ATTACHMENT I

ST. LUCIE UNIT 1

TECHNICAL SPECIFICATIONS

MARKED UP PAGES

FIGURE 3.2-3
Allowable Combinations Of Thermal Power And P_T^T

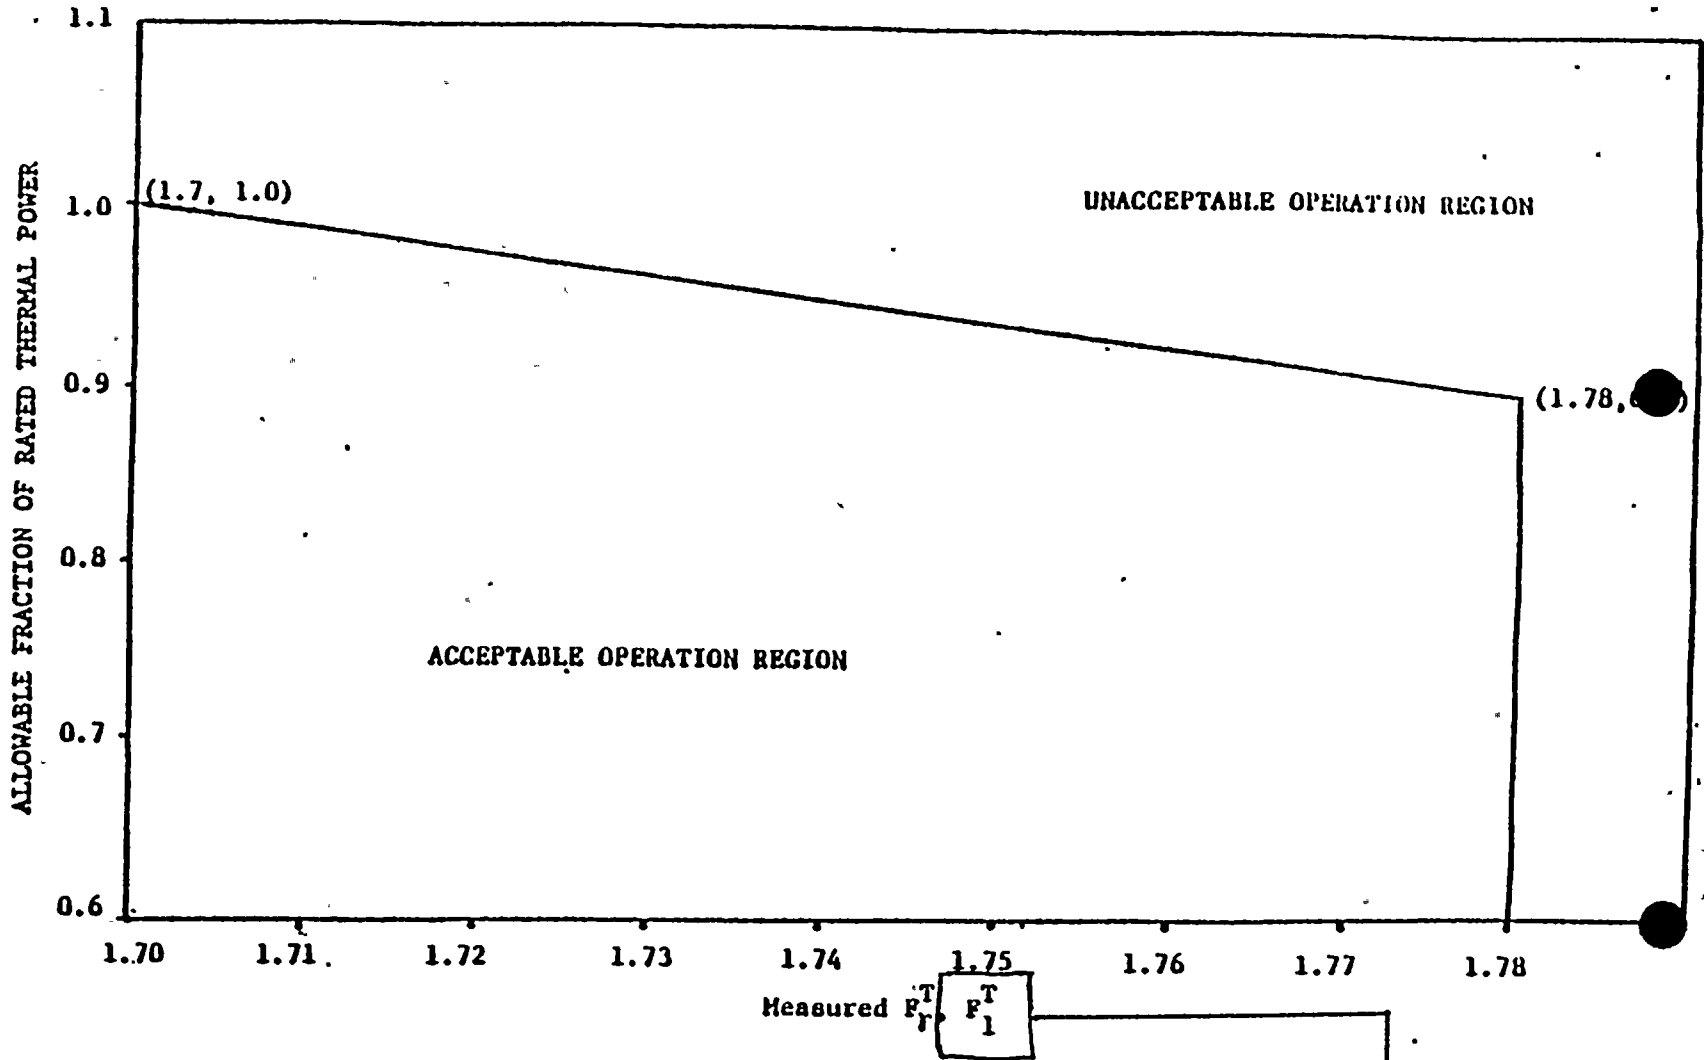
DELETE

6. Item: Page 3/4 2-8
- Action: Reference to " F_{xy}^T " is deleted from Figure 3.2-3. Additionally the term " F_1^T " is deleted.
- Discussion: The deletion of the " F_{xy}^T " term from Figure 3.2-3 is needed due to the deletion of Technical Specification 3/4.2.2 (which defines the limits of the peaking factor - F_{xy}^T). The term " F_1^T " in the title "Measured F_R^T, F_1^T " is a typographical error. The term should have been " F_{xy}^T " which is being deleted.
7. Item: Page 3/4 2-11
- Action: References to the "Total Planar Radial Peaking Factor, F_{xy}^T " and to the limits of Specification 3.2.2 are deleted from the Technical Specification 3/4.2.4. Revised text accounts for the deletions.
- Discussion: These changes are based on the deletion of Technical Specification 3/4.2.2.
